DeKalb County Historic Preservation Commission

Staff Report

D. 971 Oakdale Road, FIELD Landscape Architecture. Renovate a historic guest house, construct a garage, construct a detached shed, install a swimming pool, renovate driveway, and install new hardscape and landscaping. **247562**

L-1.00

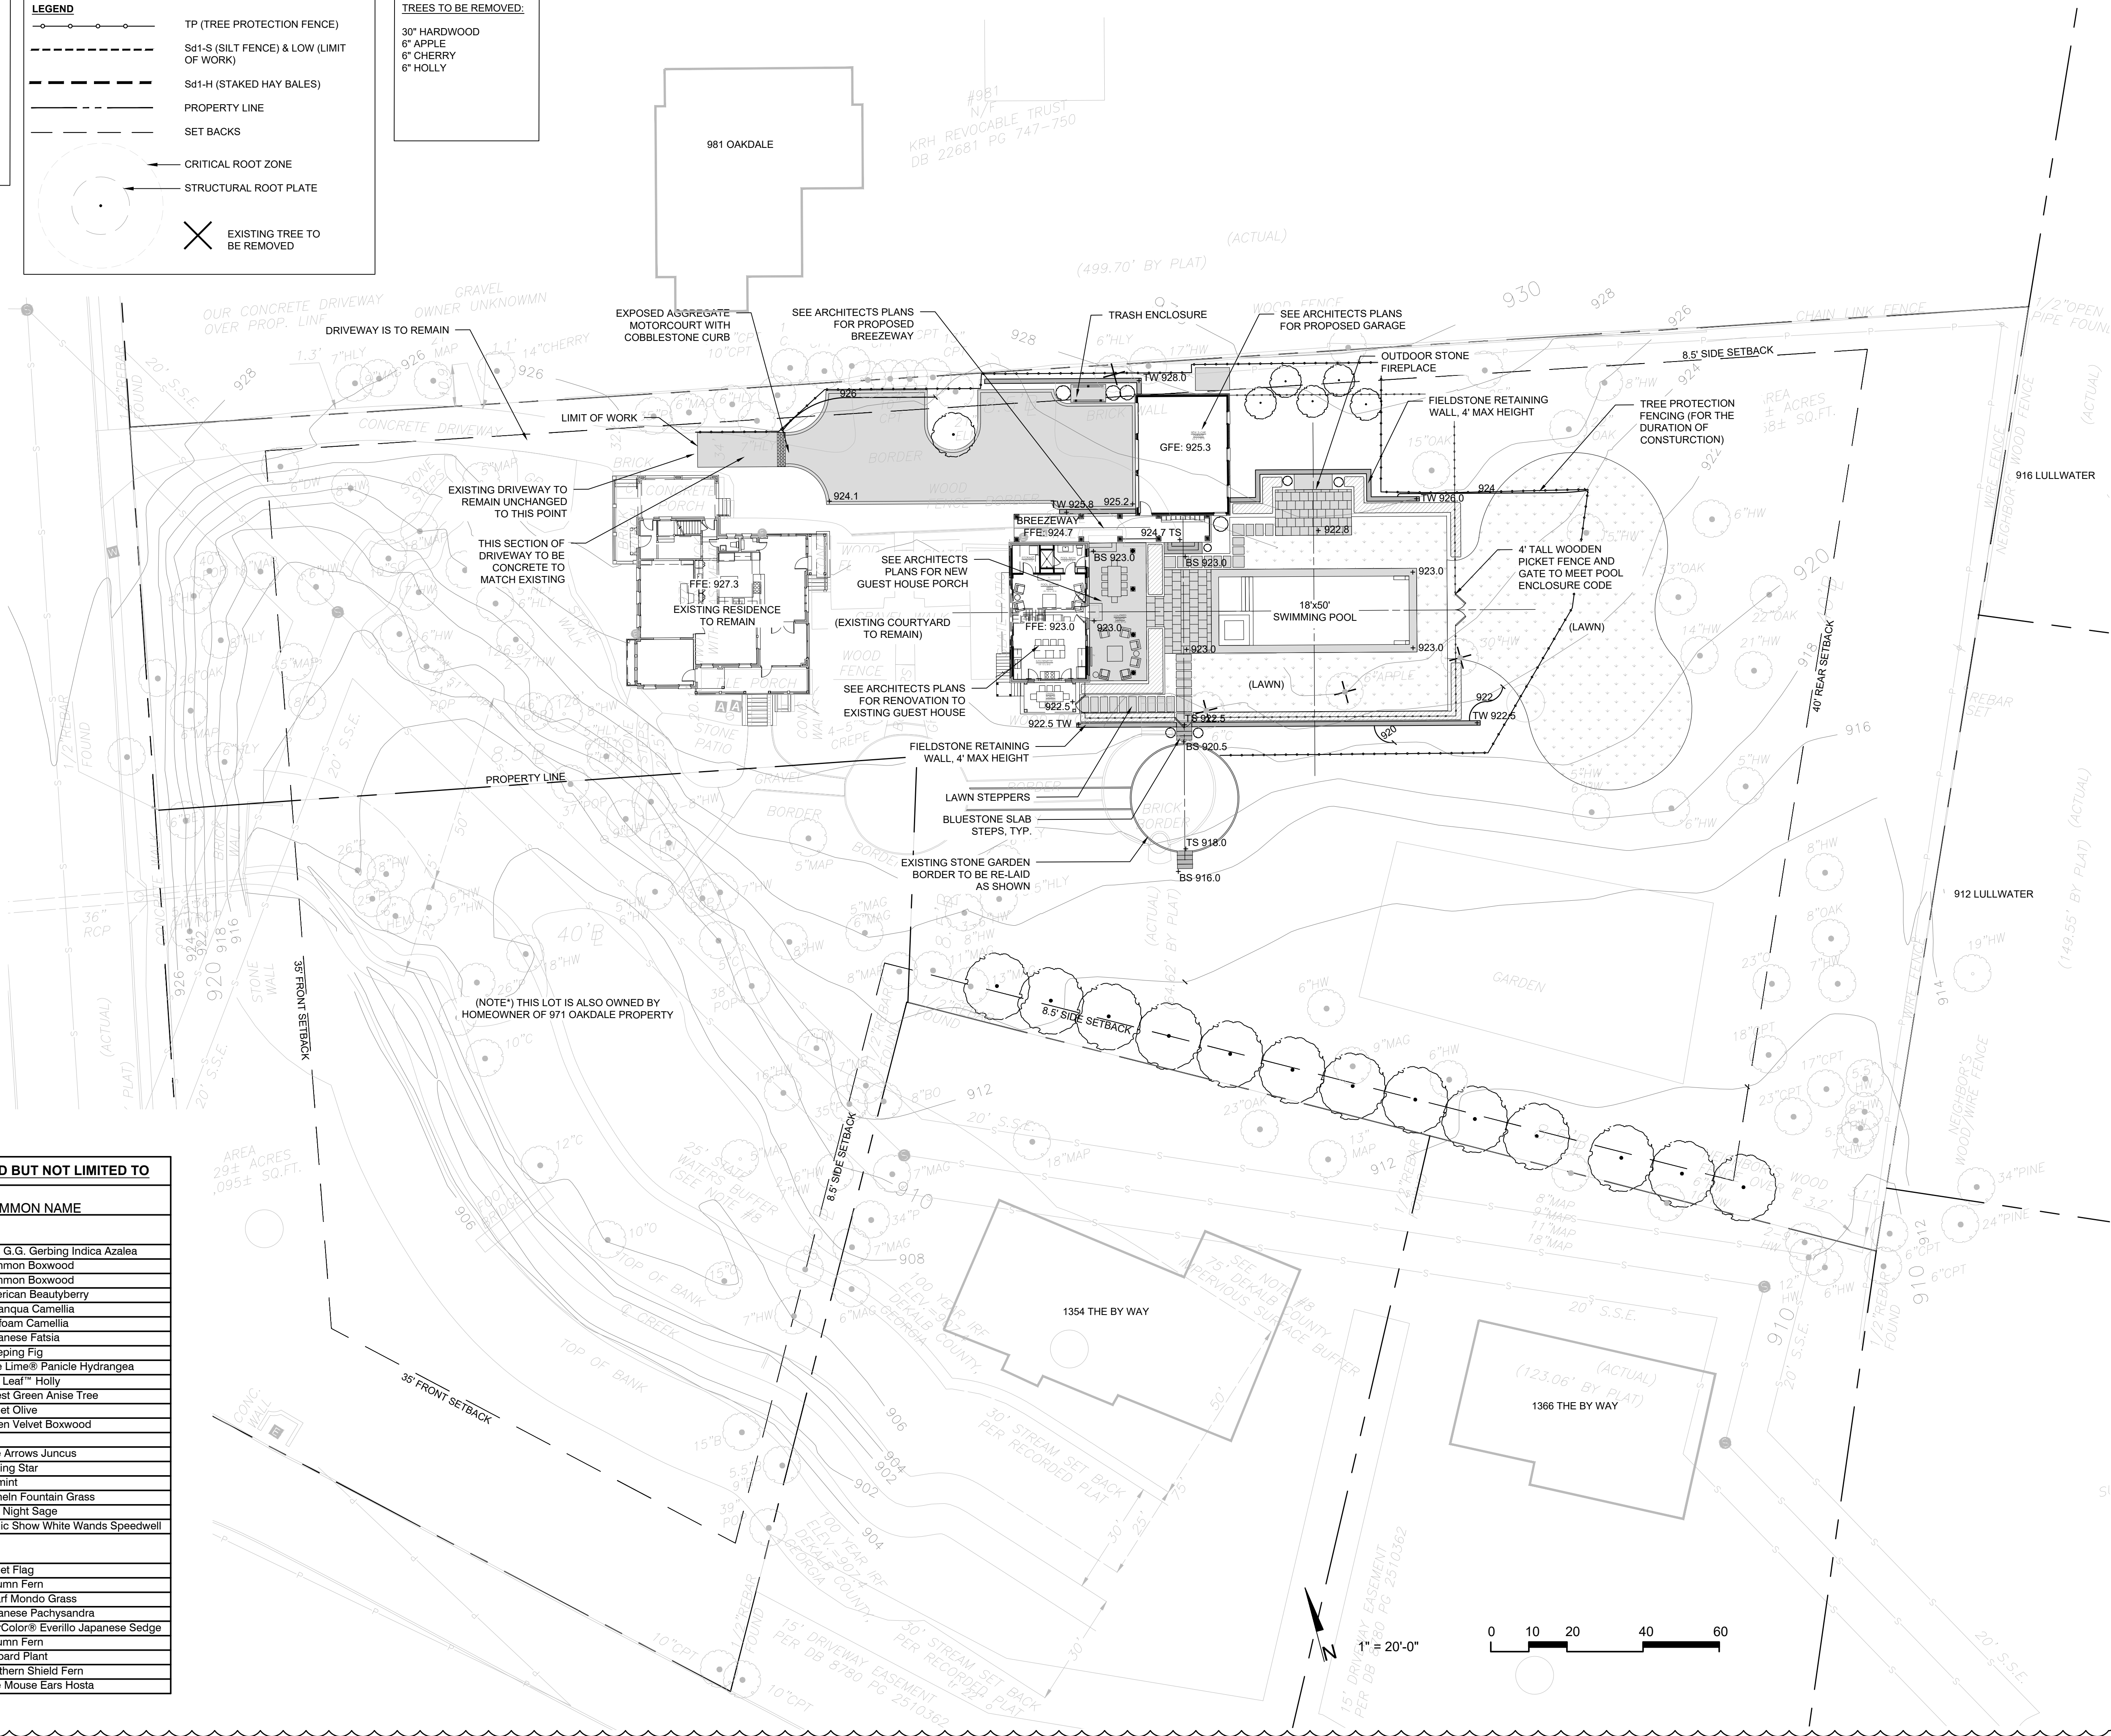
2. The current proposed site plan does not show the neighboring properties; can you provide an updated site plan to show the neighboring properties and their proximity to the proposed work?

5. What is the square footage for the proposed storage shed?
6. What are the proposed modifications to the existing driveway? Will the driveway be expanded or reduced, and if so, what is the current size of the driveway and how will its size be modified?

2. The current proposed site plan does not show the neighboring properties; can you provide an updated site plan to show the neighboring properties and their proximity to the proposed work? - [Neighboring properties have been outlined and added to the site plan.](#)

6. What are the proposed modifications to the existing driveway? Will the driveway be expanded or reduced, and if so, what is the current size of the driveway and how will its size be modified? - The existing driveway is a total of 4,458SF, and the proposed size after modifications will be 3,843SF. The existing driveway will remain unchanged up to the point of the existing covered porch corner, approximately. After this point, the existing driveway is to be removed and the footprint reduced and modified to connect to the newly proposed garage. The adjustments to the driveway can be seen between the existing survey and the hatched design on L-1.00.

2 WOODEN FENCE + PEDESTRIAN GATE
SCALE : NTS

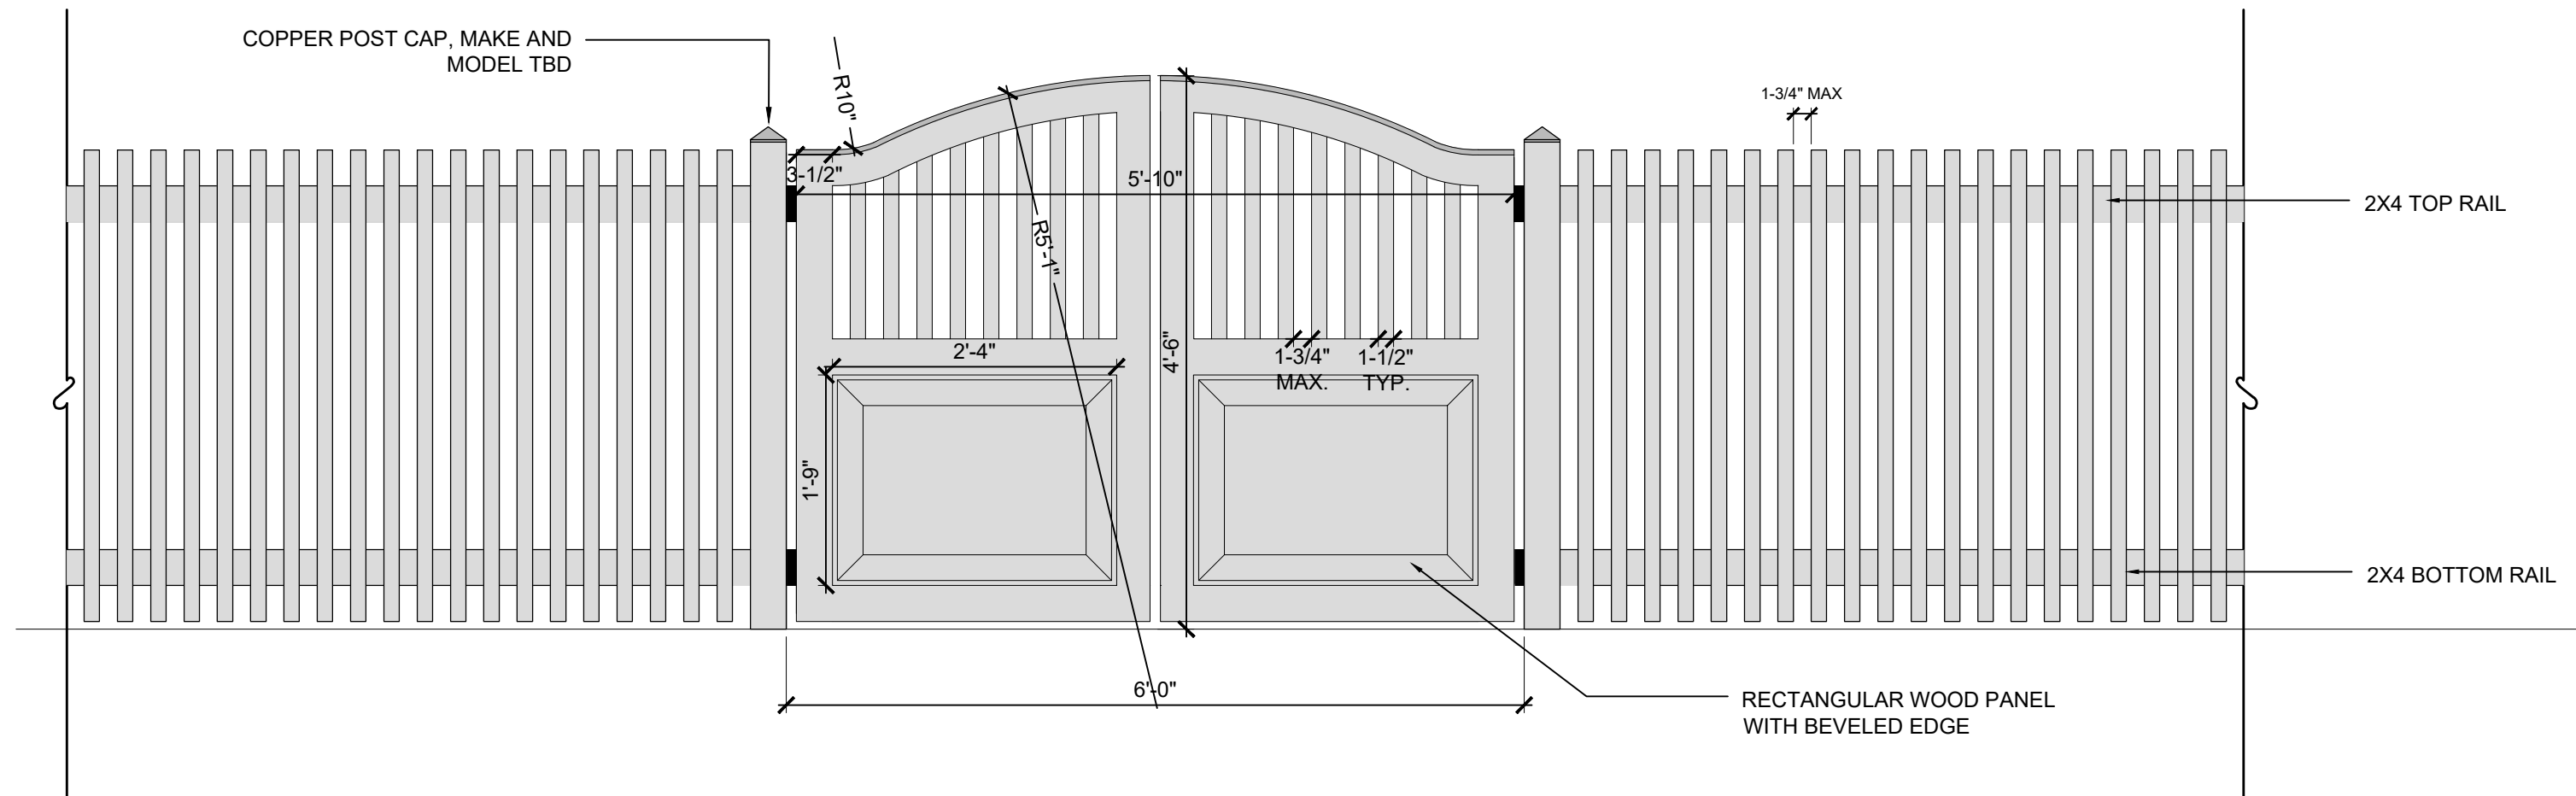
Approve with Modifications. At the request of the applicant, the proposed sports court and storage shed should be withdrawn from this application as these elements are no longer included within the scope of work. In accordance with Guidelines 6.1.2, 6.1.3, and 6.3, the columns on the front façade of the historic guest house should be retained as the columns are a character defining feature of the historic structure and the style in which it was constructed. In order to comply with the DeKalb County Health Code, the proposed fencing surrounding the swimming pool should be raised to 5 feet in height.

7. Will the proposed fence be self-latching or automatic?
8. Will any work be done on the historic house and if so, what work will be done? Can you provide drawings for those modifications?

A2.1

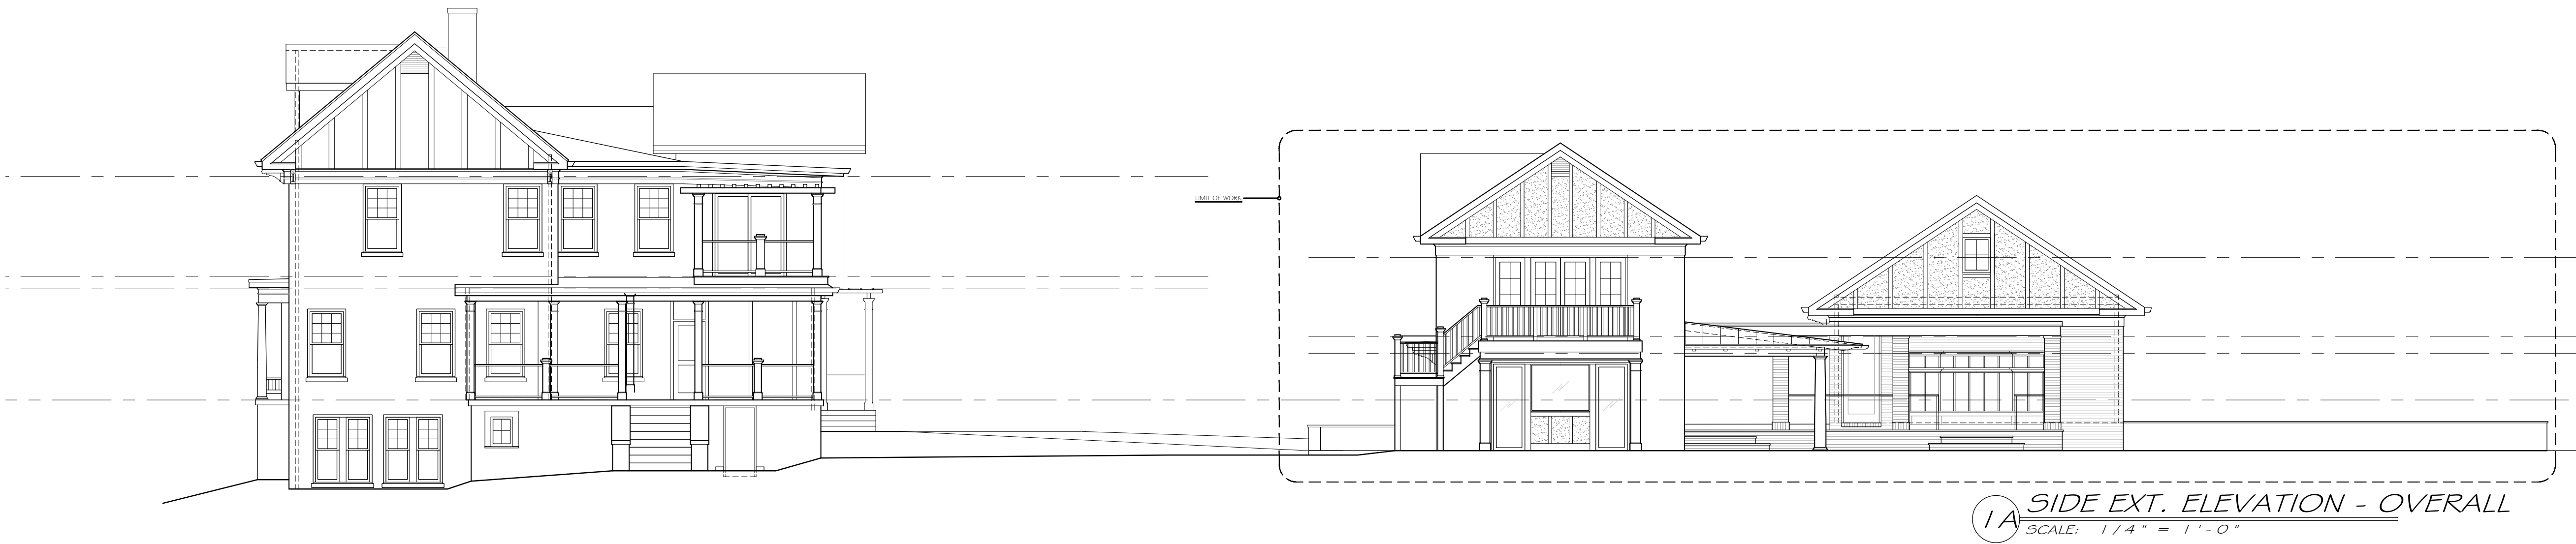
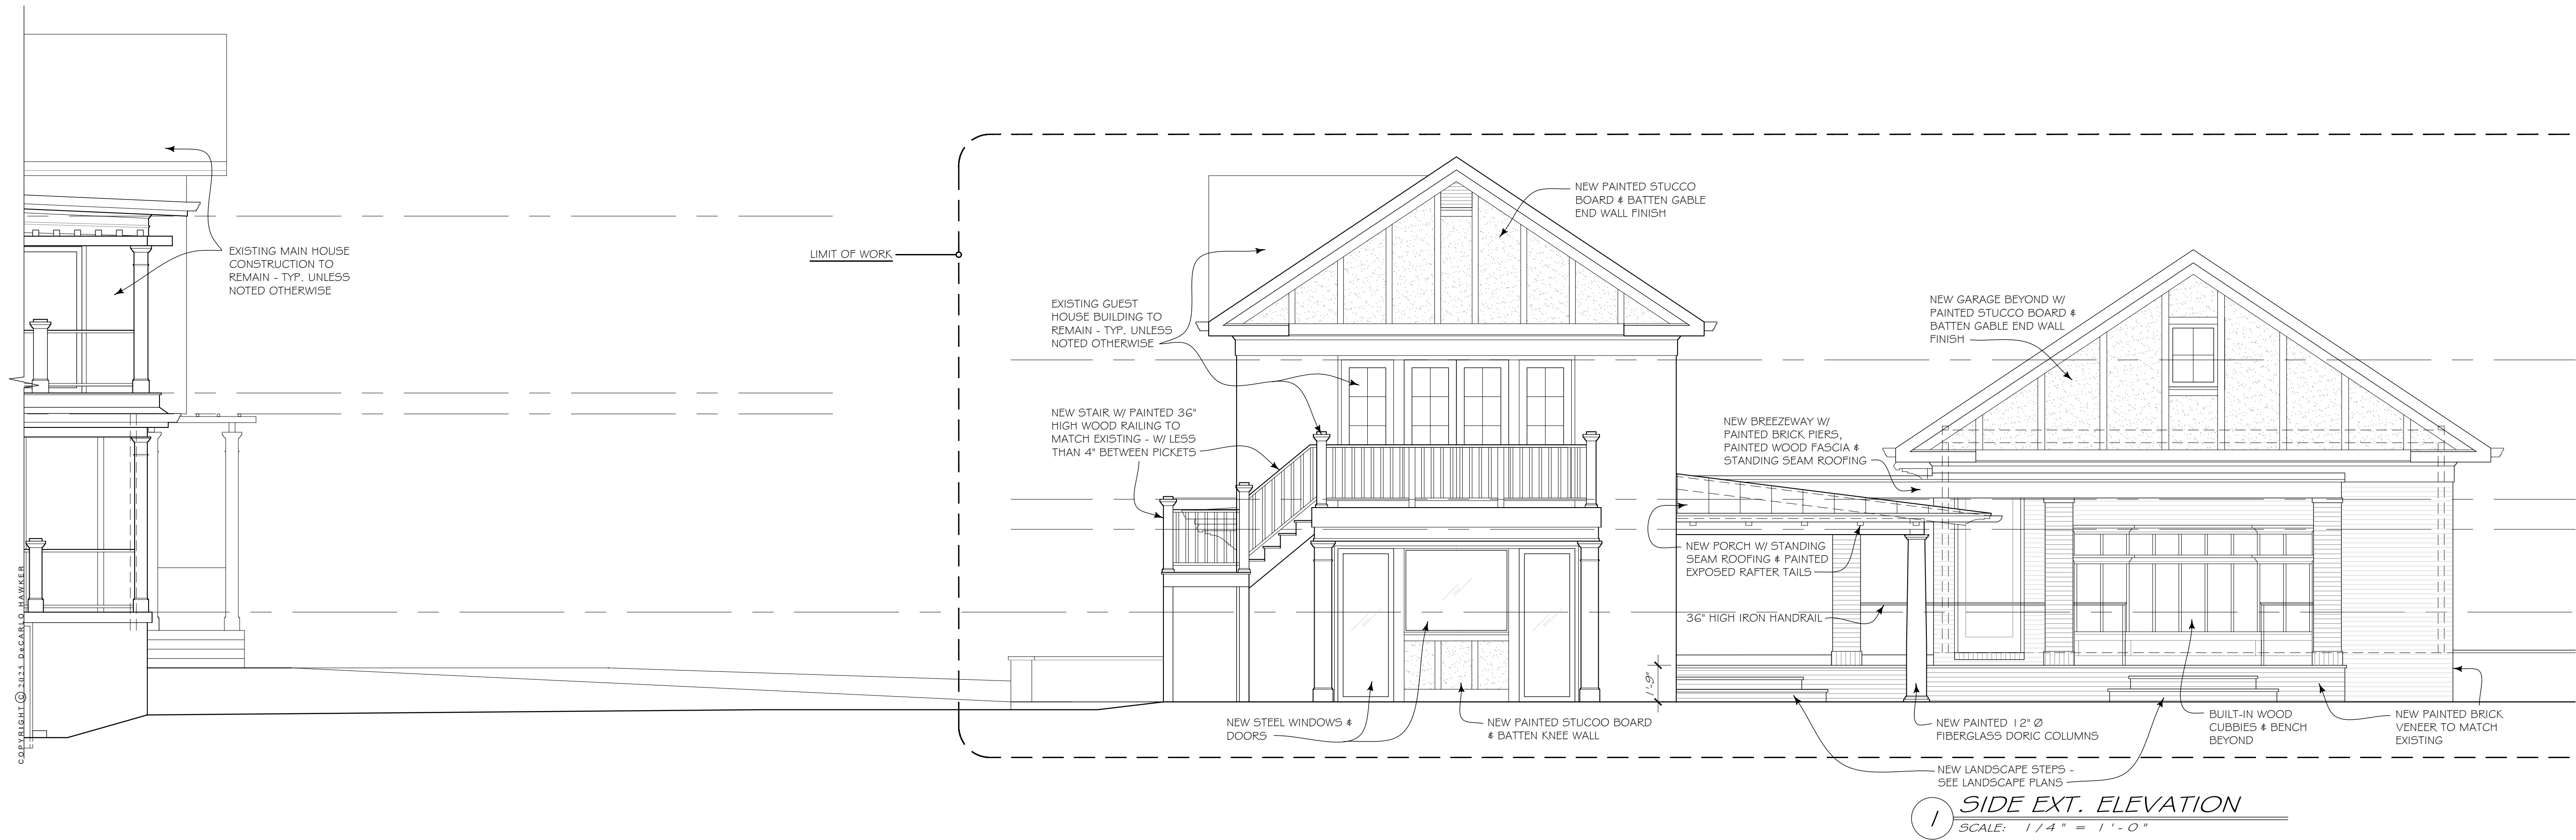
1. Can you provide individual drawings to show the existing and proposed elevations of the renovated guest house with notes regarding the proposed changes in the exterior materials and design?

1. Can you provide individual drawings to show the existing and proposed elevations of the renovated guest house with notes regarding the proposed changes in the exterior materials and design? - [Please refer to sheets A2.4 & A2.5 for existing elevations of the guest house. The elevation drawings and accompanying notes on A2.1 & A2.2 show the existing vs. proposed material and design changes.](#)
